B1 Means of escape unit
model CR-E1

- Rear Dormer revised to align with Dormer of No 80 and fascia alterations
- Rooflight added

Title: Revised Proposals for Rear Roof Slope

MR & MRS. SYMES, 79 LAWN RD. NW3
LOFT CONVERSION, INCLUDING REAR
DORMER & SIDE DORMER OVER
LANDING WINDOW

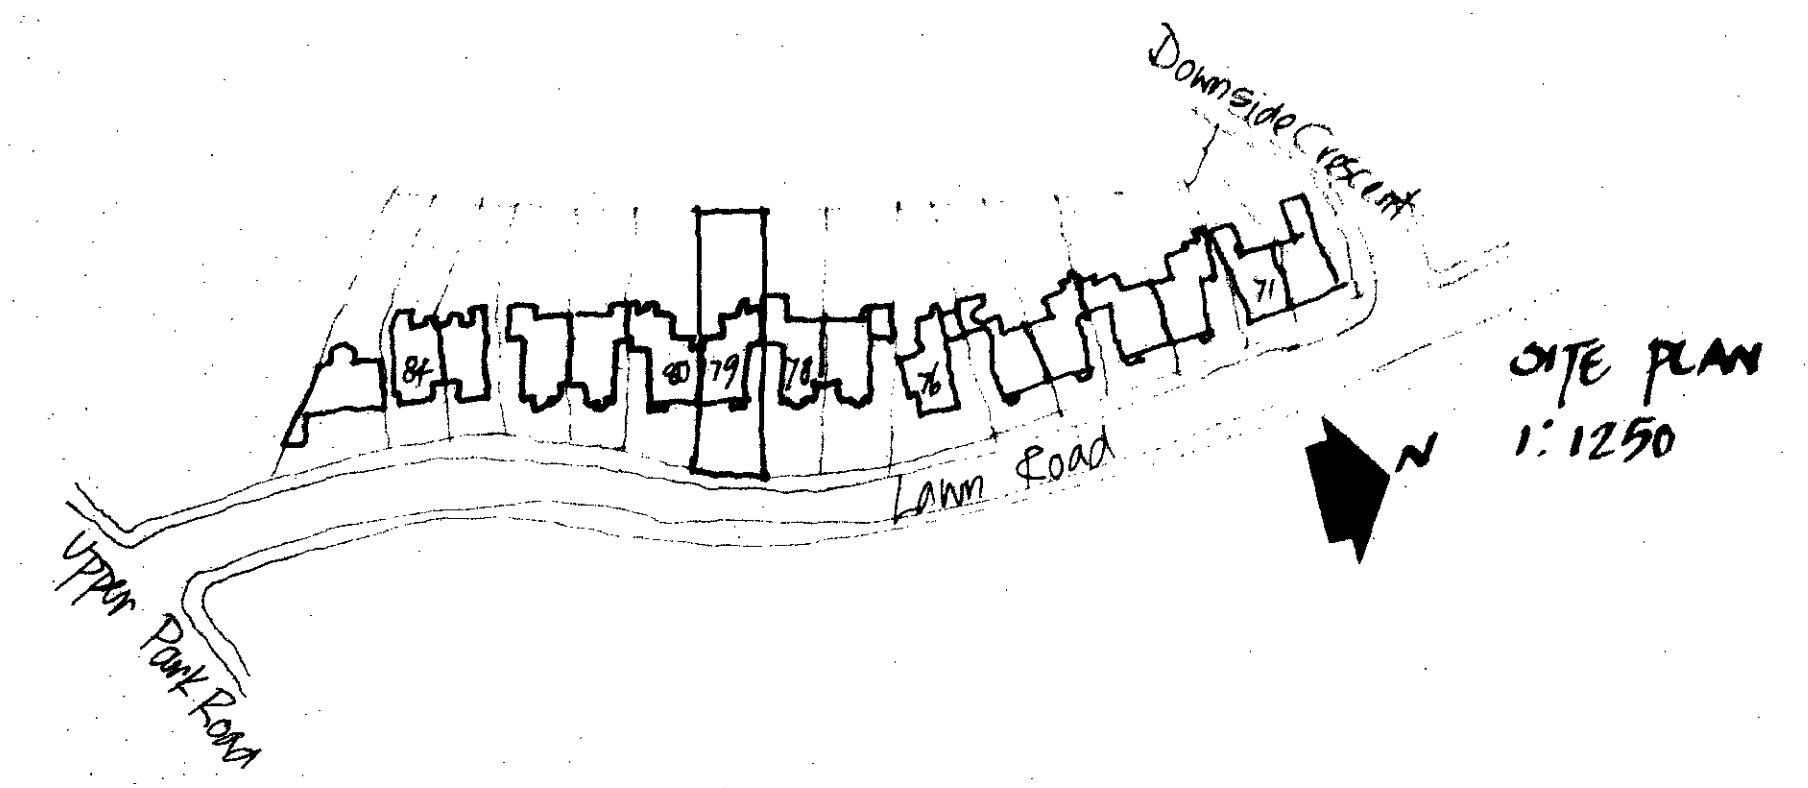
Dormer over landing window:

Code 5 lean flat roof.

Head detailing including all timber mouldings and dentils to match existing first floor bay window on front elevation.
